**ARCHITECTURAL REVIEW FINDINGS AND  
DECISION  
\*\* APPROVAL WITH CONDITIONS \*\***

Case #: AR-15-03  
Project: Wireless Communication Facility (WCF) 112th/Brown Portland General Electric (PGE) T-Mobile  
Location: No Street Address (Tax Lot 2S1 34AC 09400)  
Applicant: Owen Whitcomb, Land Use Associate (206-369-6323; Applicant file no. PO01230B Ibach Park Brown )

## ENLARGED SITE PLAN

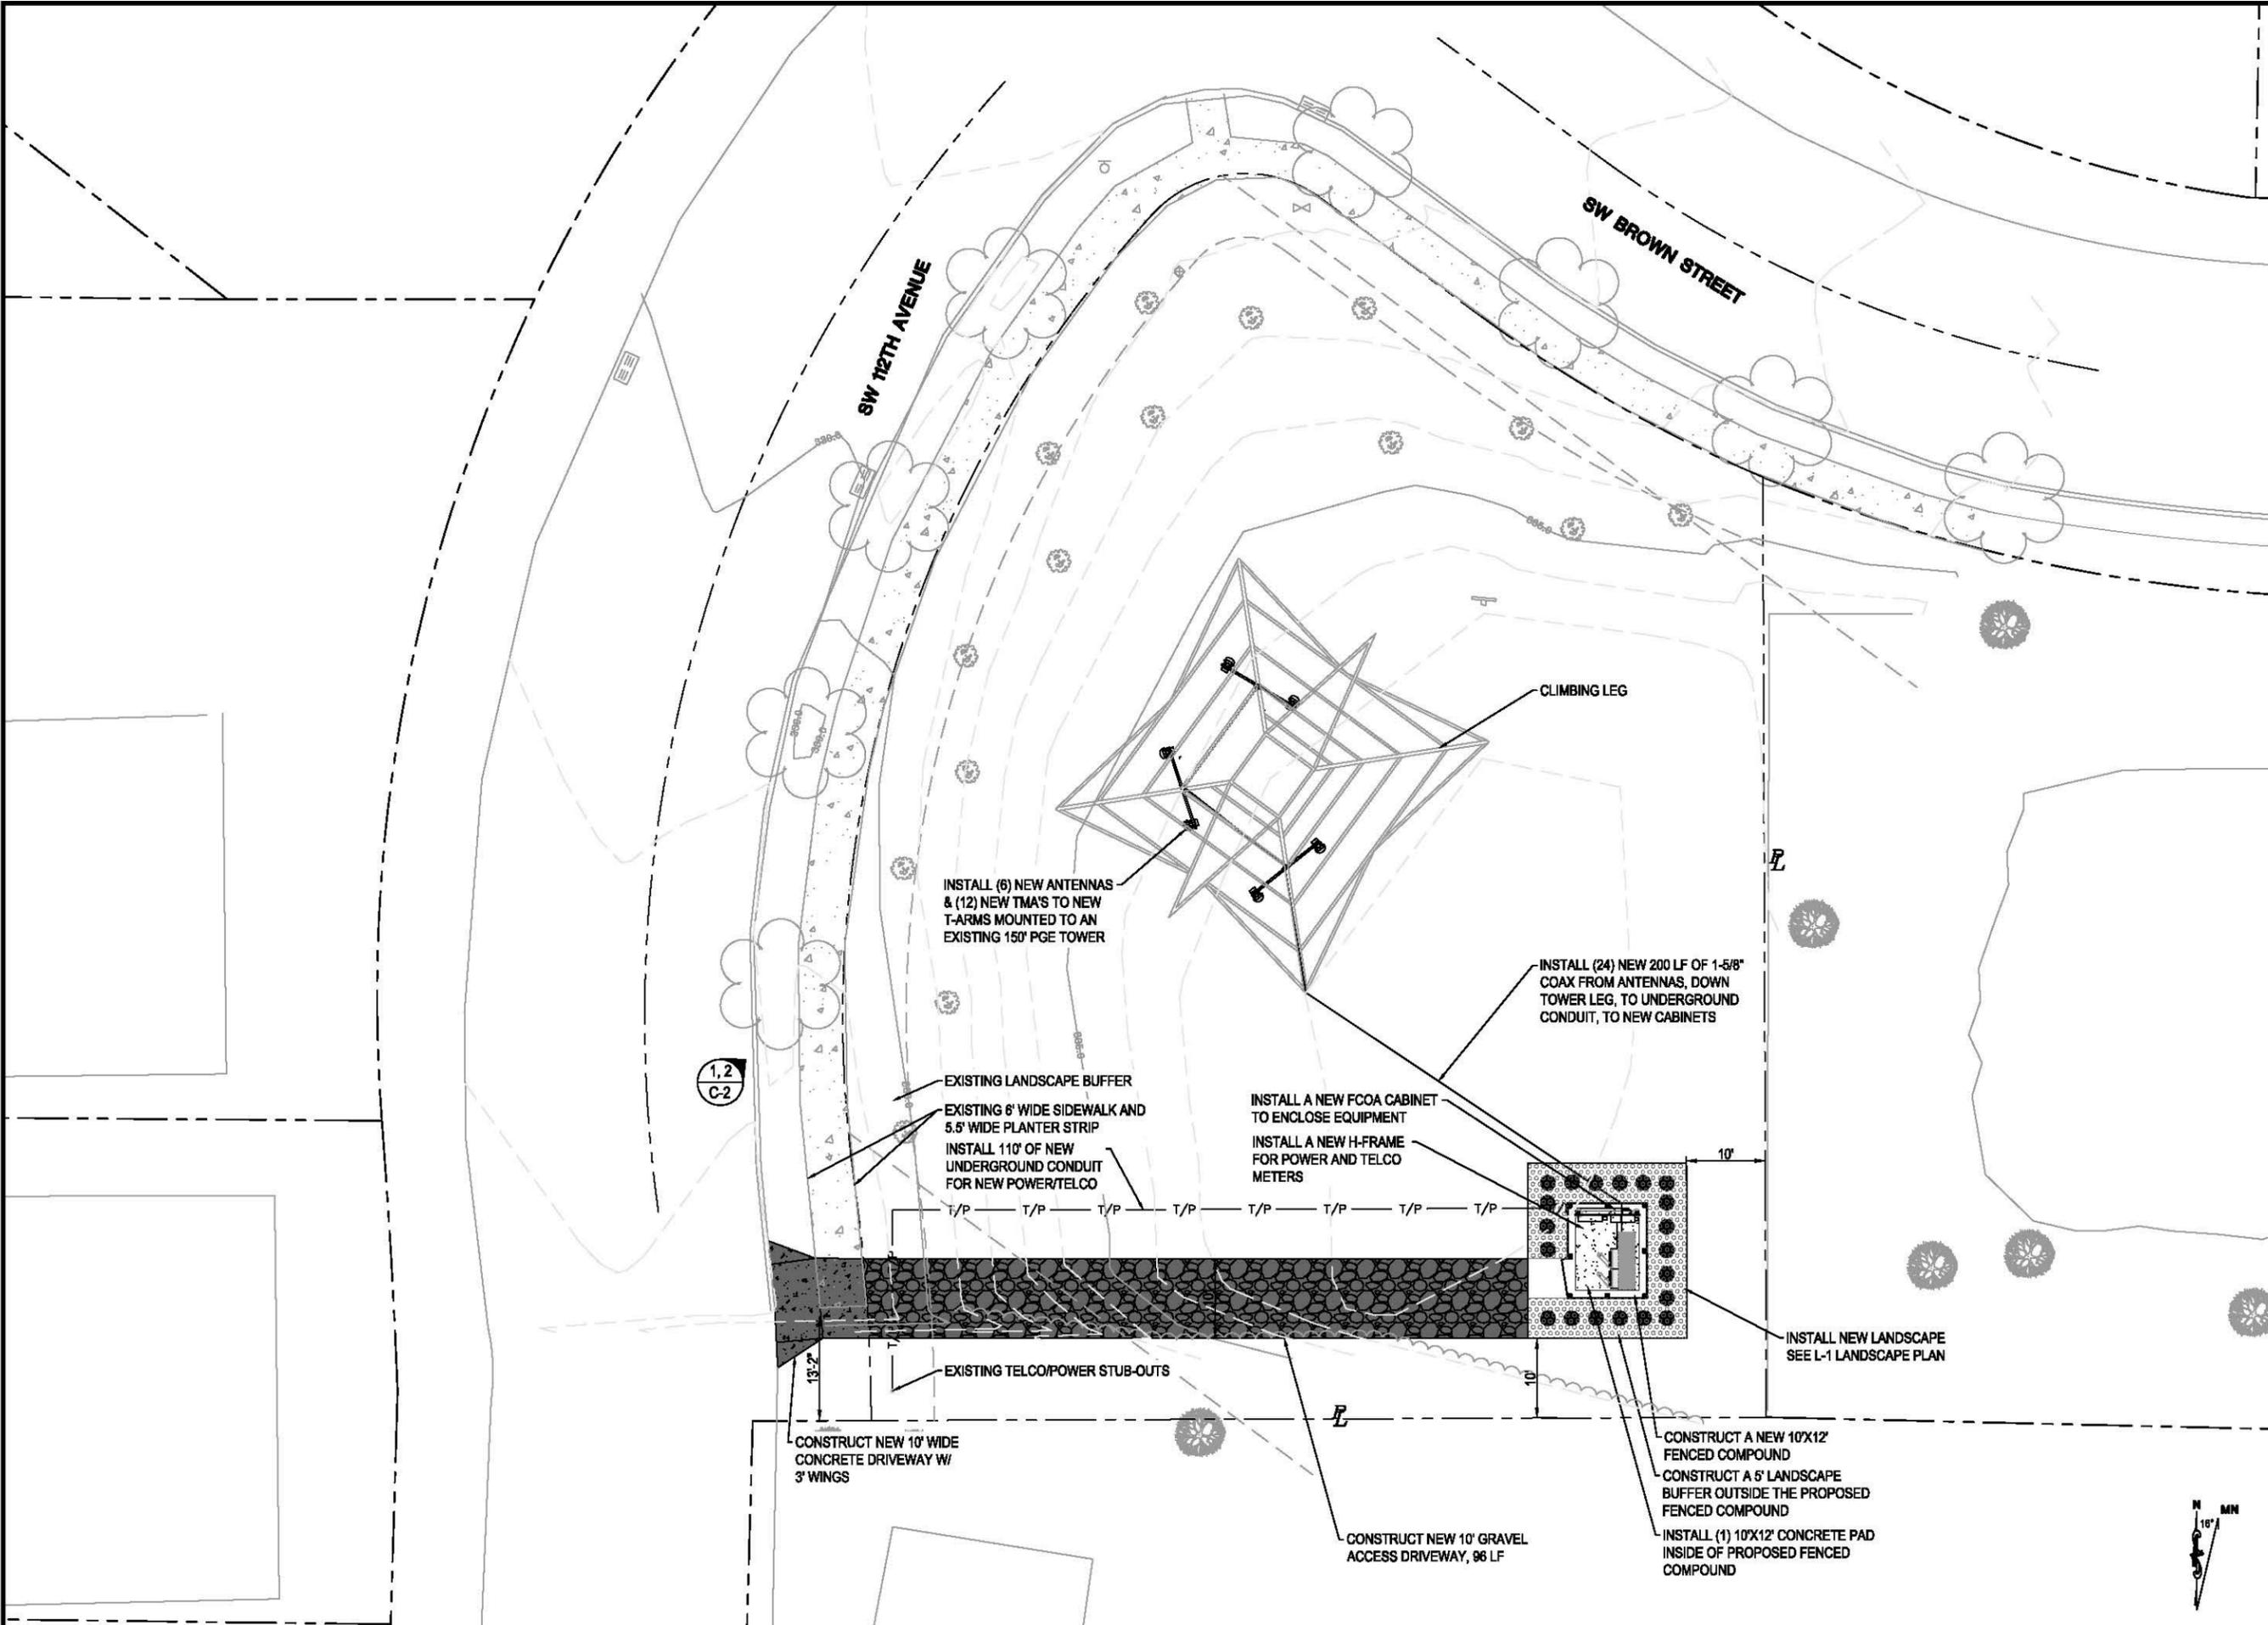
A 20-foot wide access for maintenance vehicles is proposed to SW 112<sup>th</sup> Avenue at the south side of the lot as far from the intersection with SW Brown Street as possible. This is acceptable. The applicant will need to submit final plans for the 20-foot wide access to SW 112<sup>th</sup> Avenue, for review and approval.

- *The applicant shall submit final plans for the 20-foot wide access to SW 112<sup>th</sup> Avenue, for review and approval.*

**SHEET TITLE:**  
**FULL ELEVATIONS**

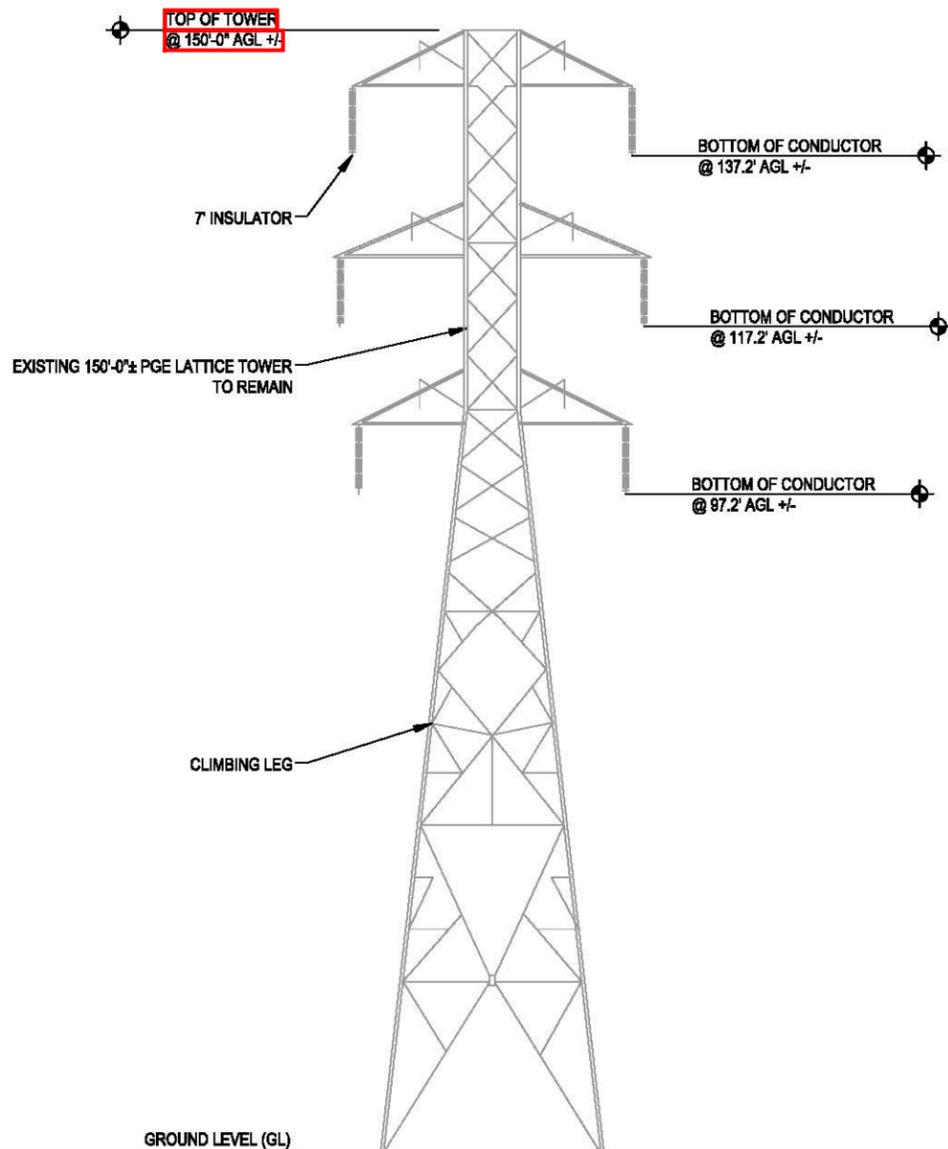
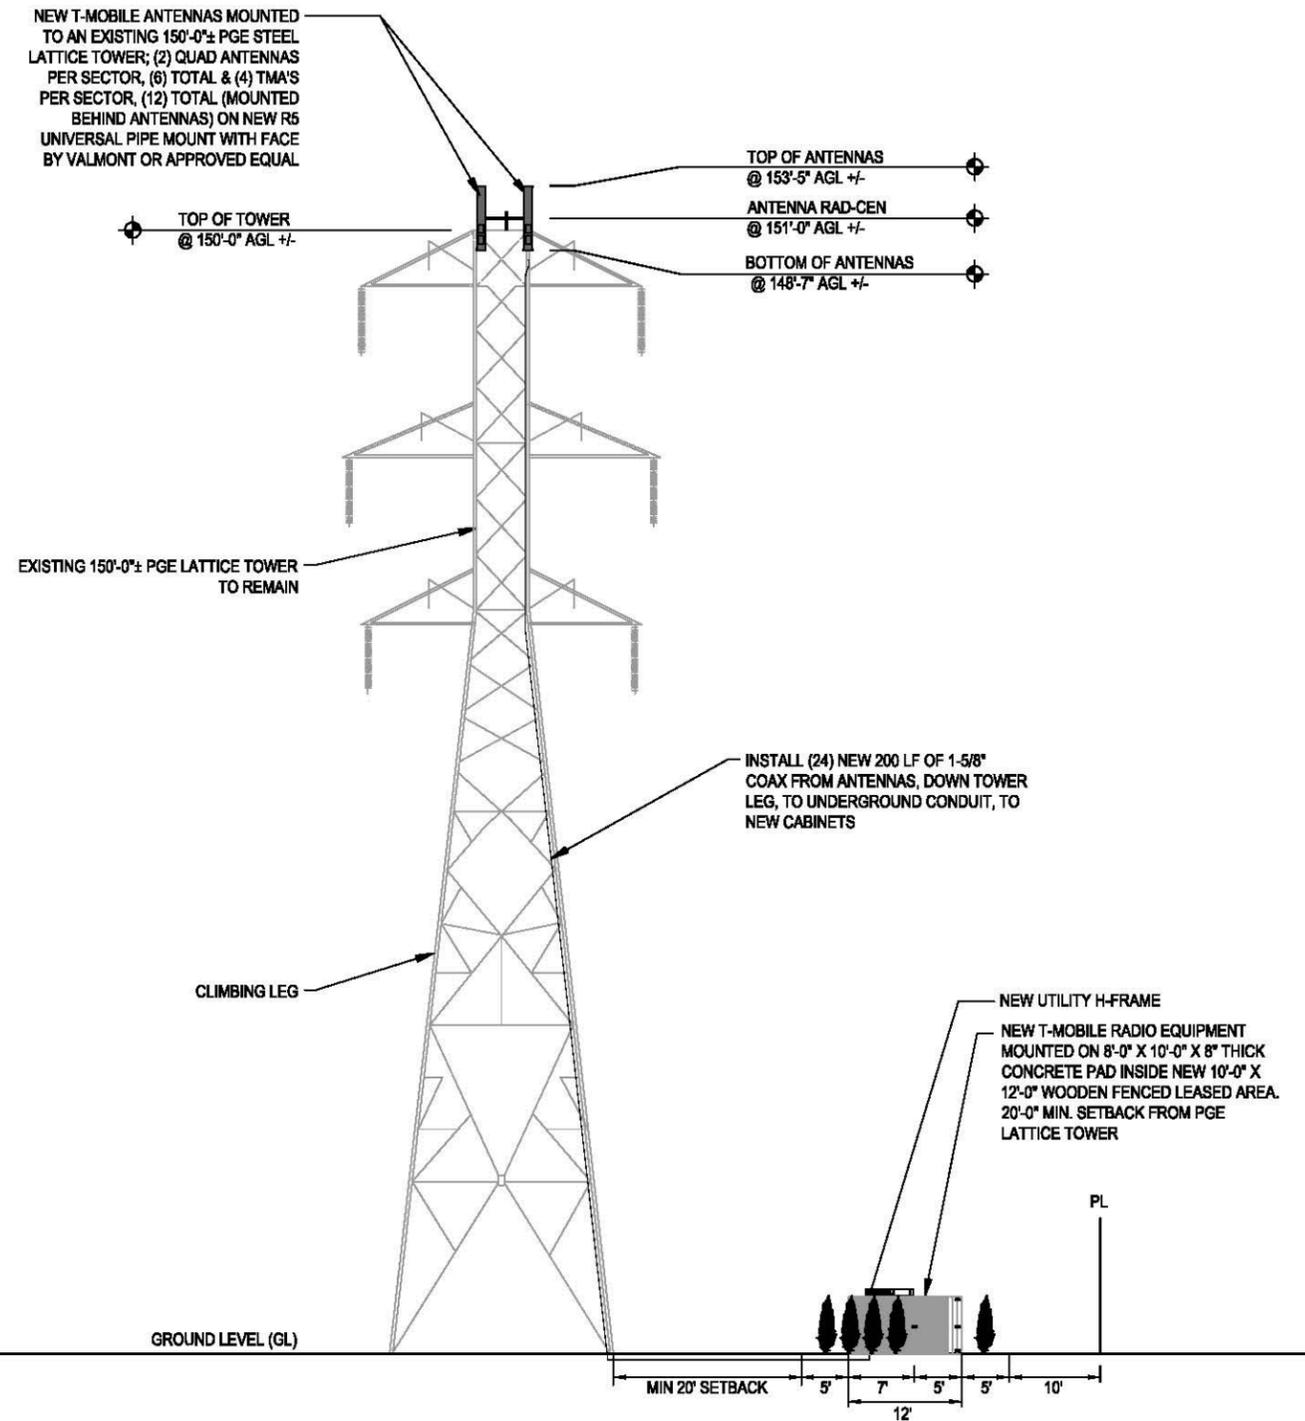
- 3.) The proposed project only increases overall structure height by some 3' 5" as depicted on sheet C-3 of the architectural site plan.
- 4.) This provision is not applicable as there were no significant stands of vegetation on the parcel in question.
